TECHNICAL INFORMATION

85997

Subject ▶ Change of Wheel Cover Ass'y, Bearing box, Motor Housing

For Models ▶ GA5010, GA5011, GA5020, GA5020C, GA5021, GA5021C, 9562CH, 9562CR, 9562CVH, 9562CVR, 9565CLR, 9565CR, 9565C, 9565CV, 9565CVL, 9565CVR, 9565H, 9565PC, 9565PCV

Fig. 1

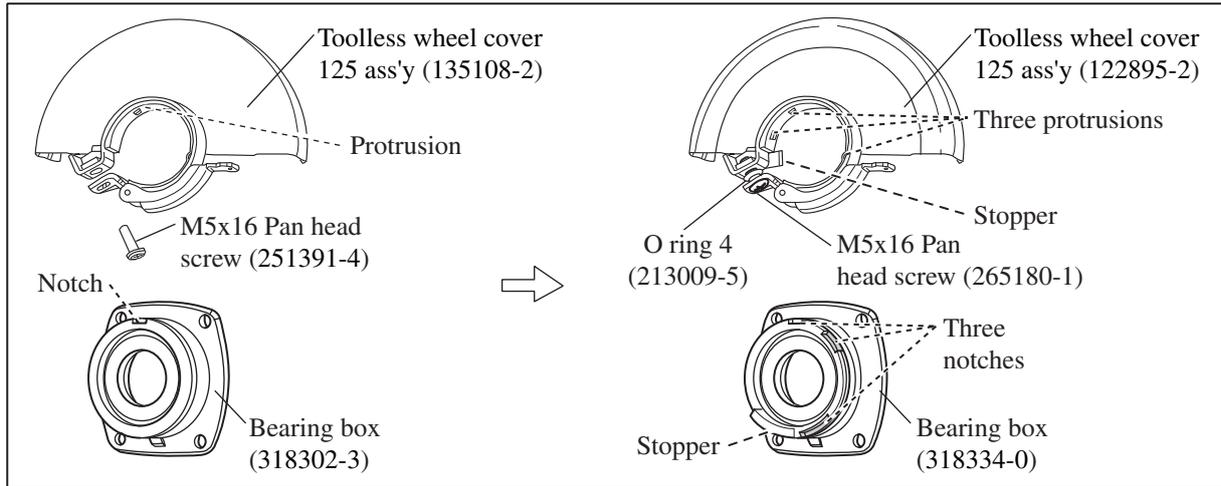
Description ▶ Wheel cover ass'y, Bearing box and Motor housing have been changed to comply with the clause of IEC/ EN60745 EU mechanical directives.
See Figs. 1 to 8.

Item No.	Current part		Q'ty	I/C	New part		Q'ty	Note
See Fig.1.	048	Toolless Wheel Cover 125 Ass'y 135108-2		1	No	Toolless Wheel Cover 125 Ass'y 122895-2		1	The current remains available. ↑ 9562CH for Austria, France, Germany, Italy, Netherlands, Poland, Reunion, Russia, Spain, Sweden, Switzerland, UK 9562CR for Austria, France, Germany, Netherlands, Reunion, Spain
	—					O Ring 4 213009-5		1	
	049	Pan Head Screw M5x16 251391-4		1	←	Pan Head Screw M5x16 265180-1		1	↓ 9562CVH for Austria, France, Germany, Italy, Netherlands, New Caledonia, Poland, Reunion, Russia, Spain, Sweden, Switzerland, Tahiti
	9562CH, 9562CR, 9562CVH, 9562CVR, 9565CR, 9565CVR, 9565H: 053 9565C, 9565CV: 054	Bearing Box 318302-3		1	No	Bearing Box 318334-0		1	9562CVR for Austria, France, Germany, Netherlands, Poland, Reunion, Spain 9565C for Austria, France, Germany, Italy, Netherlands, Poland, Reunion, Russia, Spain, Sweden, Switzerland, UK 9565CR for Austria, France, Germany, Netherlands, Reunion, Russia, Spain, Switzerland 9565CV for Austria, France, Germany, Italy, Netherlands, New Caledonia, Poland, Reunion, Russia, Spain, Sweden, Switzerland, Turkey, UK 9565CVR for Austria, France, Germany, Italy, Netherlands, Poland, Reunion, Spain, Sweden, Switzerland, Turkey 9565H for Austria, France, Germany, Italy, Netherlands, Poland, Reunion, Russia, Spain, Sweden, Switzerland, Tahiti, UK Interchangeable as a set

Fig. 2

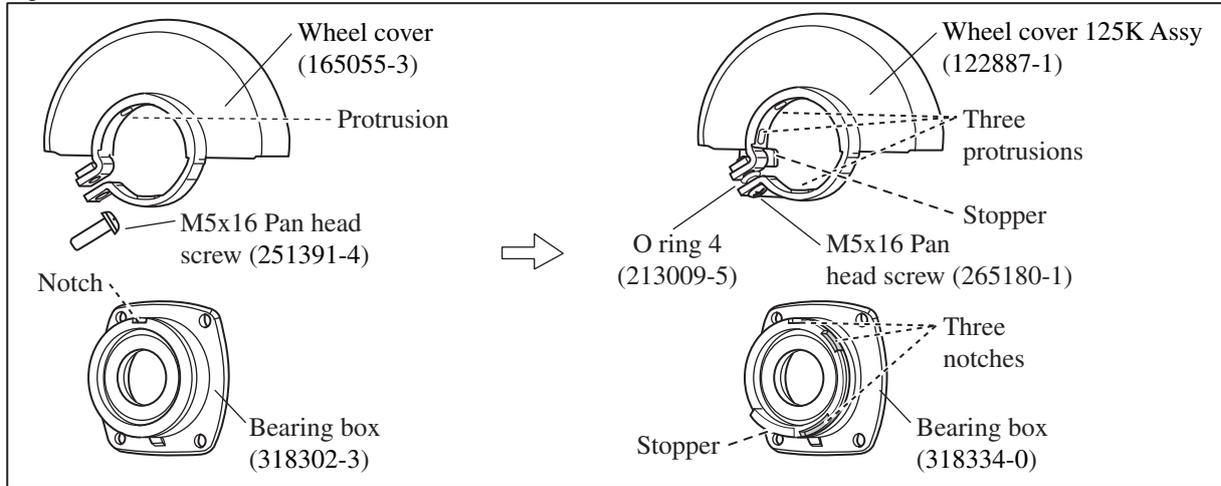
See Fig.2.	A02	Wheel Cover 165055-3		1	No	Wheel Cover 125K Assy 122887-1		1	The current remains available. ↑ 9565CLR for Austria, France, Germany, Italy, Netherlands, Poland, Reunion, Spain 9565CVL for Austria, France, Germany, Italy, Netherlands, Poland, Reunion, Russia, Spain, Sweden, Switzerland, UK
	A05	Pan Head Screw M5x16 251391-4		1					
	—					O Ring 4 213009-5		1	↑ Component of 165055-3/ 122887-1
	—					Pan Head Screw M5x16 265180-1		1	↓
	9565CLR: 053 9565CVL: 054	Bearing Box 318302-3		1	No	Bearing Box 318334-0		1	Interchangeable as a set
See Fig.3.	048	Wheel Cover Ass'y 125268-8		1	No	Wheel Cover 125K Assy 122887-1		1	The current remains available. ↑ 9565H for Austria, France, Germany, Italy, Netherlands, Poland, Russia, Spain, Sweden, Switzerland, UK Interchangeable as a set
	—					O Ring 4 213009-5		1	
	049	Pan Head Screw M5x14 265103-9		1	←	Pan Head Screw M5x16 265180-1		1	↓
	053	Bearing Box 318302-3		1	No	Bearing Box 318334-0		1

Fig. 4

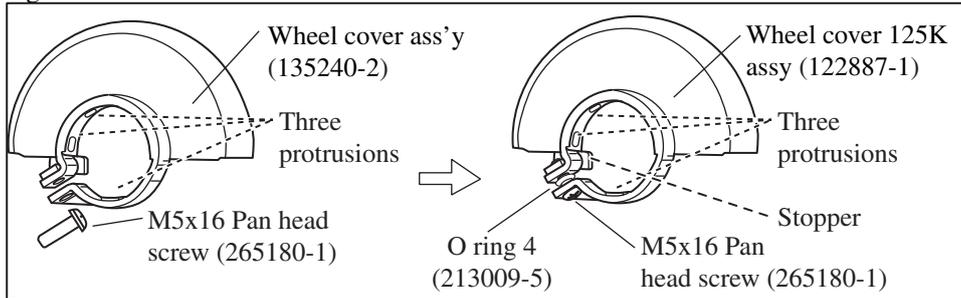
Item No.	Current part		Q'ty	I/C	New part		Q'ty	Note
See Fig.4.	GA5010, GA5011, GA5020, GA5021: 051 9565C: 048	Wheel Cover Ass'y ----- 135240-2		1	←	Wheel Cover 125K Assy ----- 122887-1		1	GA5010 for Argentina, Australia, China, New Zealand, South Africa, Switzerland, Tahiti, Turkey, UK GA5011 for Australia, France, Italy, Netherlands, Reunion, South Africa, Spain, Switzerland, Turkey GA5020 for Argentina, Australia, Chile, France, Italy, Netherlands, New Caledonia, Reunion, Spain, Tahiti, Turkey, UK GA5021 for Austria, France, Germany, Italy, Netherlands, Poland, Reunion, South Africa, Spain, Switzerland, Turkey, UK 9565C for China
	---	-----				O Ring 4 ----- 213009-5		1	
See Fig.5.	GA5020C, GA5021C: 058 9565PC, 9565PCV: 039	Toolless Wheel Cover 125 Ass'y ----- 135242-8		1	←	Toolless Wheel Cover 125 Ass'y ----- 122895-2		1	GA5020C for Chile, Germany, Italy, Netherlands, Spain GA5021C for Argentina, Australia, Austria, Cyprus, France, Germany, Italy, Netherlands, New Caledonia, New Zealand, Poland, Reunion, Russia, South Africa, Spain, Sweden, Tahiti, Turkey, UK 9565PC for Australia, Bhutan, Germany, Sweden 9565PCV for Bhutan, France, Germany, Italy, Netherlands, Reunion, Spain, Sweden, UK

Fig. 6

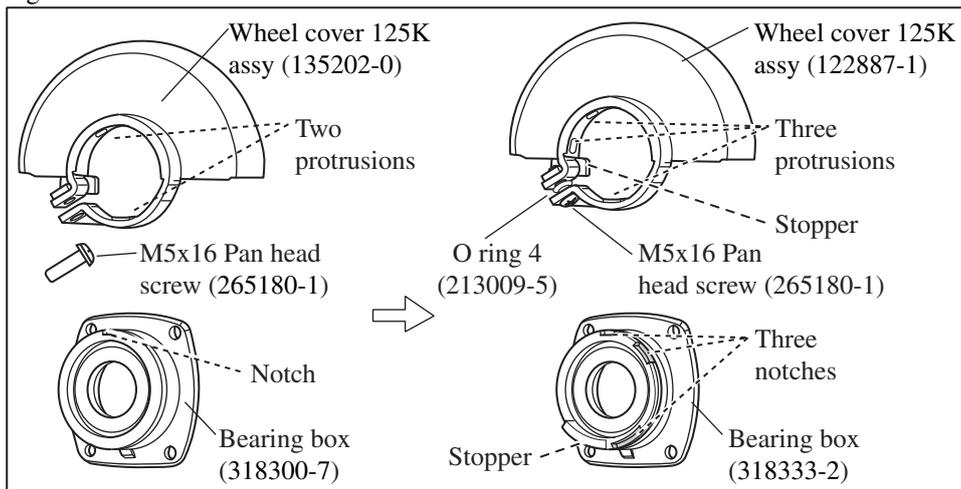
---	-----				O Ring 4 ----- 213009-5		1	
See Fig.6.	051	Wheel Cover 115K Assy ----- 135202-0		1	No	Wheel Cover 125K Assy ----- 122887-1		1	GA5010 for Brazil, Guam, Hong Kong, India, Kuwait, Philippines, Saudi Arabia, Singapore, Thailand, Vietnam GA5011 for Bhutan, Saudi Arabia Interchangeable as a set
	---	-----				O Ring 4 ----- 213009-5		1	
	046	Bearing Box ----- 318300-7		1	No	Bearing Box ----- 318333-2		1	
See Fig.7.	051	Wheel Cover 115K Assy ----- 135202-0		1	No	Wheel Cover 125K Assy ----- 122887-1		1	GA5020 for Indonesia, Philippines, Taiwan, Thailand, Vietnam GA5021 for Bhutan Interchangeable as a set
	---	-----				O Ring 4 ----- 213009-5		1	
	046	Bearing Box ----- 318299-6		1	No	Bearing Box ----- 318332-4		1	
See Fig.8.	040	Motor Housing ----- 417812-8		1	←	Motor Housing ----- 451779-0		1	9562CH for Austria, France, Germany, Italy, Netherlands, Poland, Reunion, Russia, Spain, Sweden, Switzerland, UK 9562CR for Austria, France, Germany, Netherlands, Reunion, Spain 9562CVH for Austria, France, Germany, Italy, Netherlands, New Caledonia, Poland, Reunion, Russia, Spain, Sweden, Switzerland, Tahiti 9562CVR for Austria, France, Germany, Netherlands, Poland, Reunion, Spain 9565C for Austria, France, Germany, Italy, Netherlands, Poland, Reunion, Russia, Spain, Sweden, Sweden, Switzerland, UK 9565CV for Austria, France, Germany, Italy, Netherlands, New Caledonia, Poland, Reunion, Russia, Spain, Sweden, Sweden, Switzerland, Turkey, UK 9565CVL for Austria, France, Germany, Italy, Netherlands, Poland, Reunion, Russia, Spain, Sweden, Switzerland, UK 9565CLR for Austria, France, Germany, Italy, Netherlands, Poland, Reunion, Spain 9565CR for Austria, France, Germany, Netherlands, Reunion, Russia, Spain, Switzerland 9565CVR for Austria, France, Germany, Italy, Netherlands, Poland, Reunion, Spain, Sweden, Switzerland, Turkey 9565H for Austria, France, Germany, Italy, Netherlands, Poland, Reunion, Russia, Spain, Sweden, Switzerland, Tahiti, UK
